MONTGOMERY COUNTY HISTORIC PRESERVATION COMMISSION
STAFF REPORT

Address:	102 East Kirke Street, Chevy Chase	Meeting Date:	11/12/2025
Resource:	Outstanding Resource Chevy Chase Village Historic District	Report Date:	11/5/2025
Applicant:	Britt & Will Williams (Luke Olson, Architect)	Public Notice:	10/29/2025
Review:	HAWP	Tax Credit:	n/a
Permit No.:	1067931 REVISION#4	Staff:	Dan Bruechert
Proposal:	Chimney Removal

ROOF PLAN

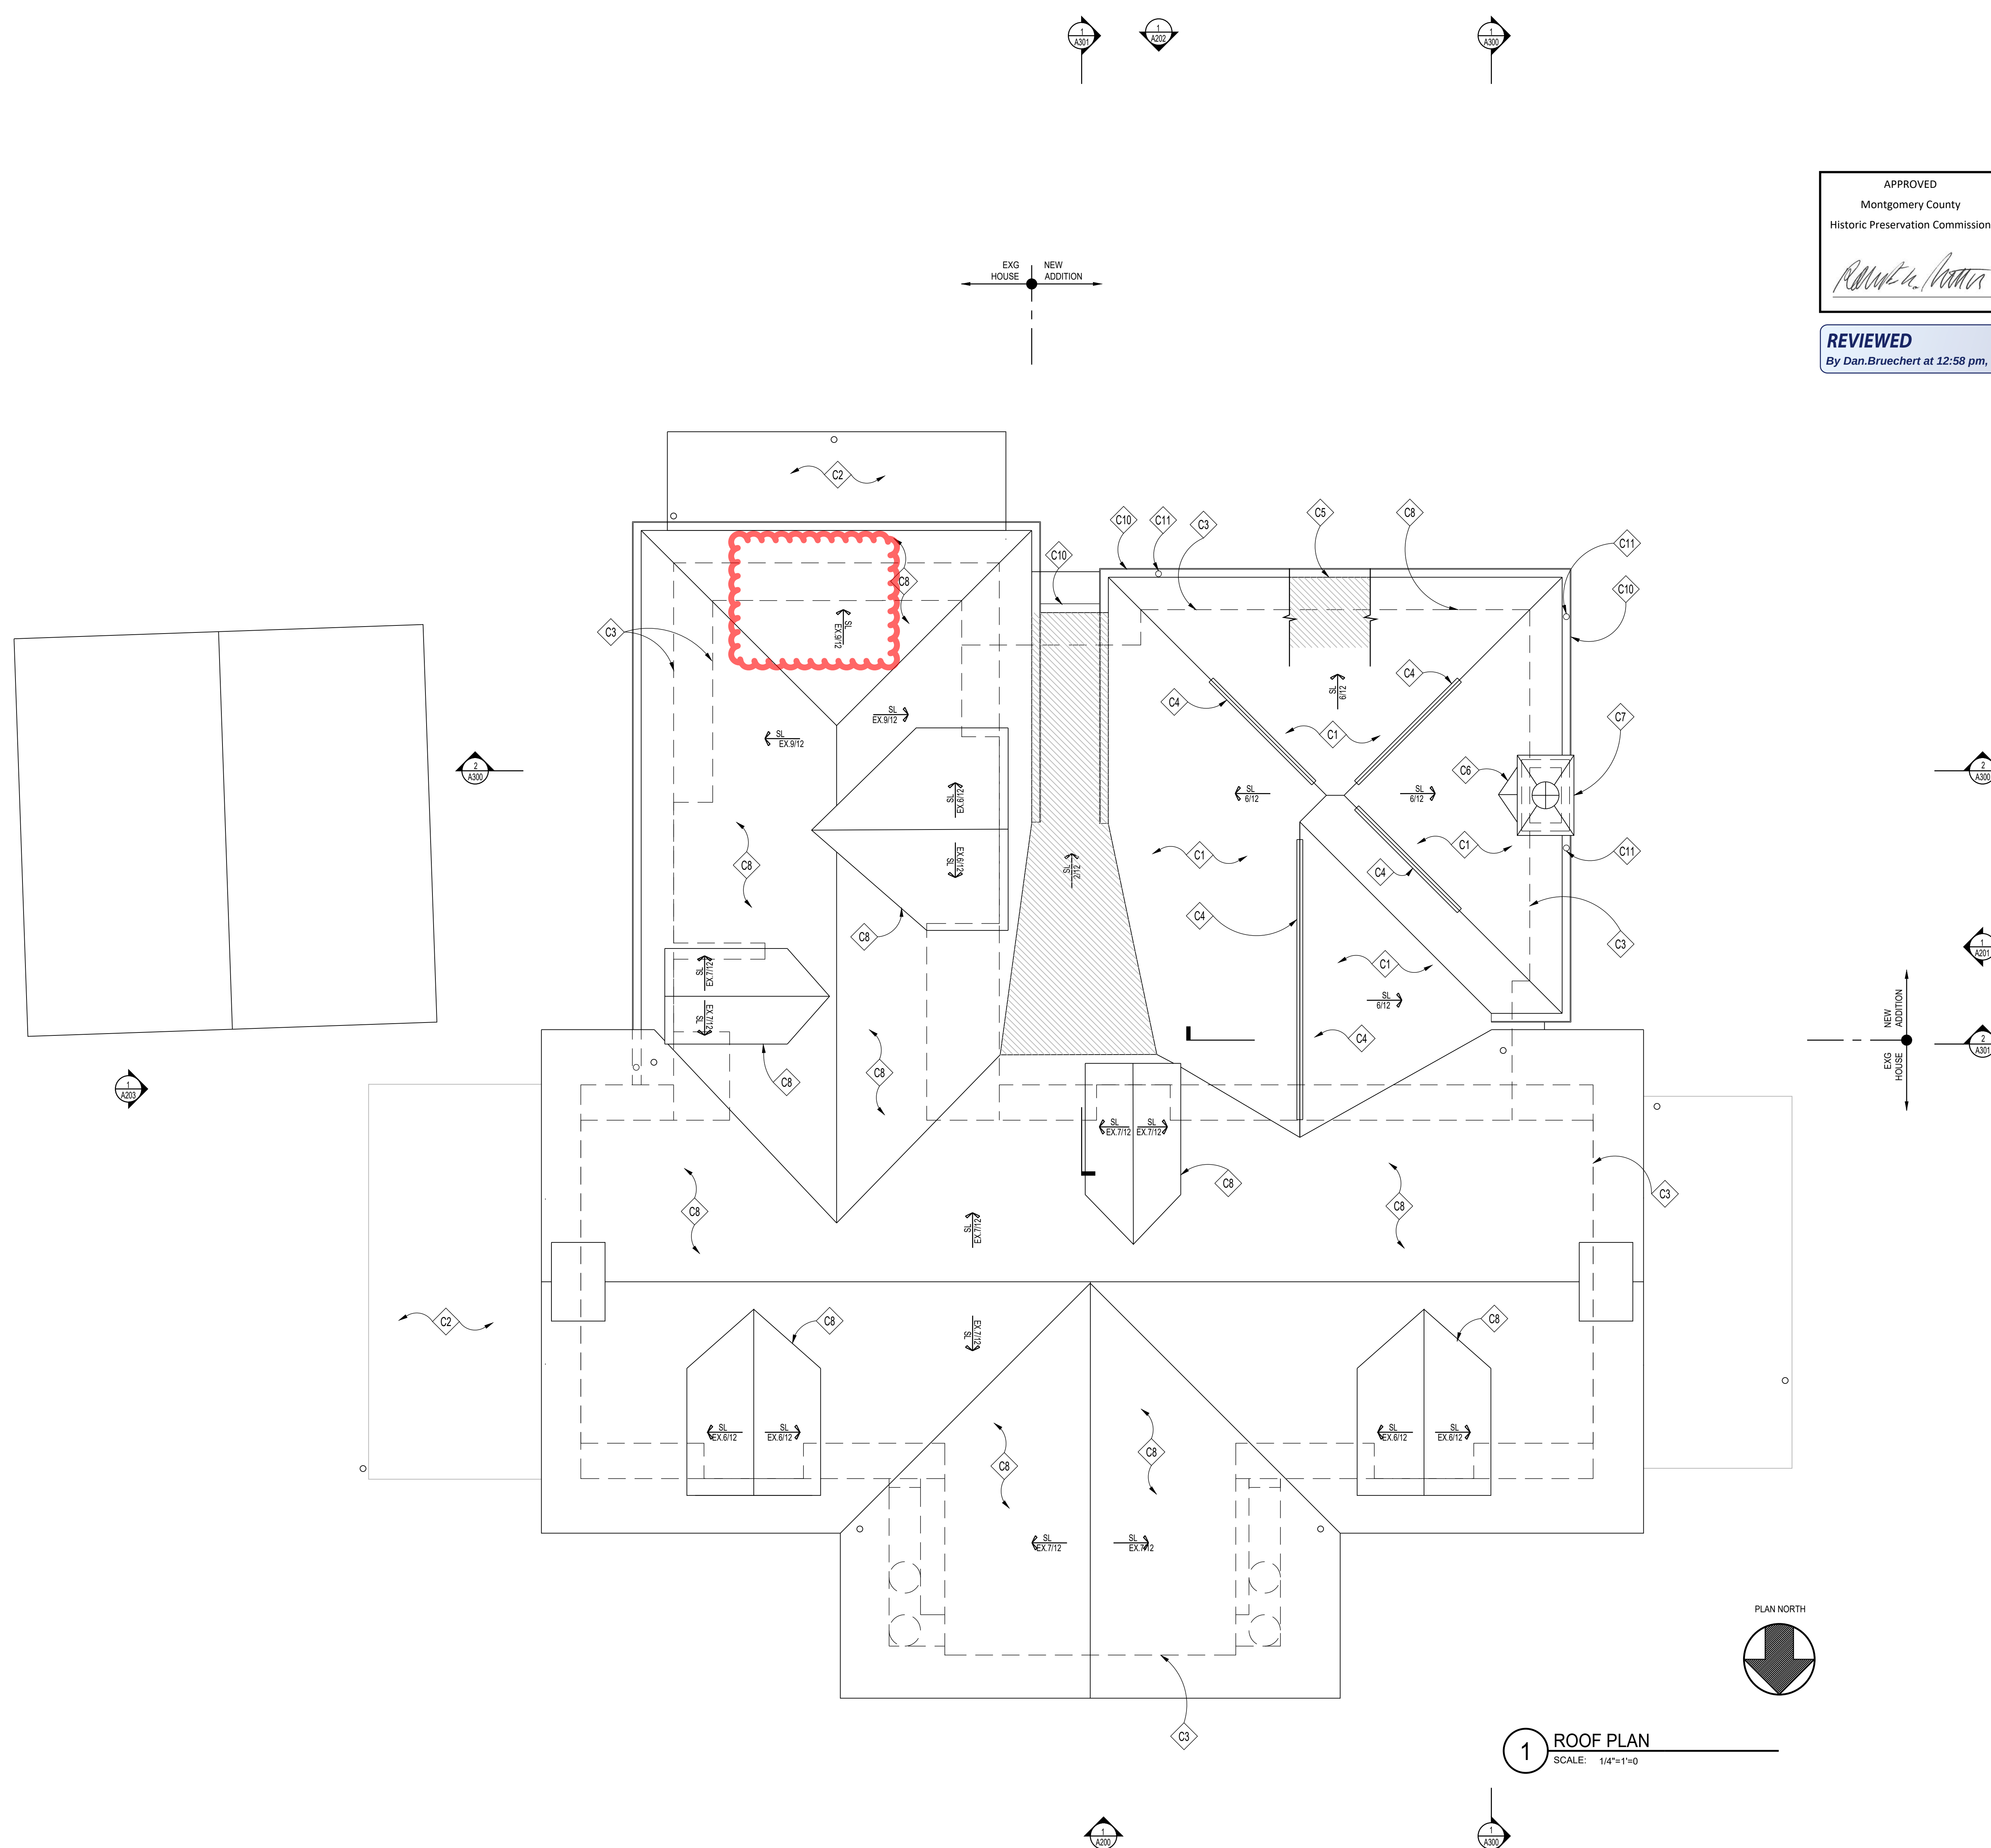
The subject property has three chimneys. There is a chimney at either gable end of the main block of the house and a chimney at the rear of the projecting-L. During construction, the applicant identified substantial damage to the rear chimney. Further investigation by a structural engineer (letter attached)

determined that chimney had deteriorated to the point it was, “unable to resist the tensile stresses at the base of the chimney.” And that is considered too tall for an unreinforced chimney due to its tall, slender proportions. The applicant proposes to remove this chimney and to repair the roof.

Staff finds that based on the analysis by the structural engineer that the existing chimney has deteriorated beyond repair and needs to be demolished. The question then is, what is the appropriate treatment for the chimney’s location?

Staff finds the rear chimney is narrower than the gable end chimneys but does have the same crown design, which shows more consideration went into the design and construction of this chimney than a purely utilitarian brick or block chimney. Additionally, because the subject property is on a corner lot, the rear chimney is visible from the public right-of-way. Staff finds additional consideration should be given to the proposal due to the subject property’s designation as an ‘Outstanding Resource.’ According to the *Design Guidelines*, these categories are established to provide the HPC with guidance as to the architectural and historical significance... [and] structures with the highest degree of importance should

Considering the design significance of the chimney and its ‘Outstanding Resource’ categorization, and because the proposed change is in a location that is visible from the public right-of-way, Staff recommends the HPC add a condition to the HAWP that requires the chimney, above the roofline, to be reconstructed. Because of the stucco exterior, Staff finds that the chimney could be constructed out of masonry or framed, provided the exterior is stuccoed to match the house and the crown is replicated. With the recommended condition, Staff finds the HAWP is appropriate under 24A-8(b)(1), the *Design Guidelines*, and *Standards #2* and *5*.

1. The chimney above the roofline must be replicated to match the dimensions and appearance of the historic chimney. Documents detailing the construction of the chimney must be submitted to Staff before the issuance of the final HAWP approval documents;
